of all the required information and documents. APPLICATION FOR PERMISSION

UNDER SECTION 16 OF

THE TOWN PLANNING ORDINANCE

Further to comment received from Urban Design and Landscape Section ("UD&L"), Planning Department ("PlanD"), Transport Department ("TD"), and Architectural Services Department ("ArchSD") on 28 and 29 July 2021, please find our responses in the enclosed Responses-to-Comments Table (Attachment 1 refers).

EDGE PLANTER DETAILS

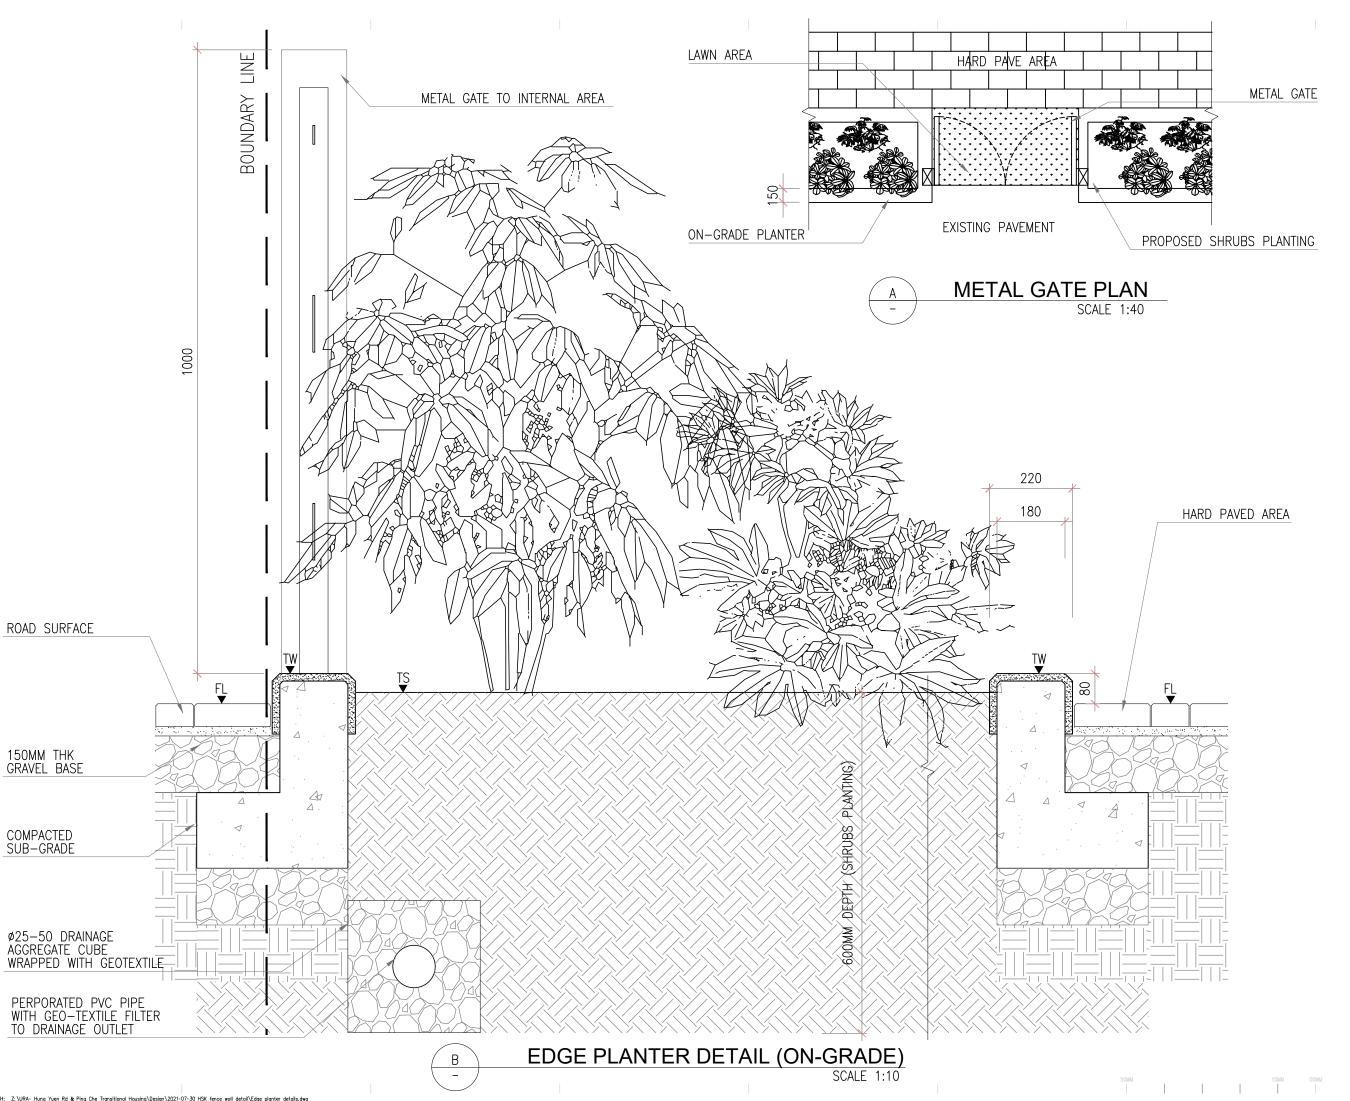
(ii)	Elaboration on the proposed landscape boundary treatments with section and elevation, or any other drawing as appropriate should be provided in the application	Low metal fence wall with at-grade planters is proposed along the Application Site boundary. Supplementary drawing "Edge Planter Details" in Appendix 1 refers.
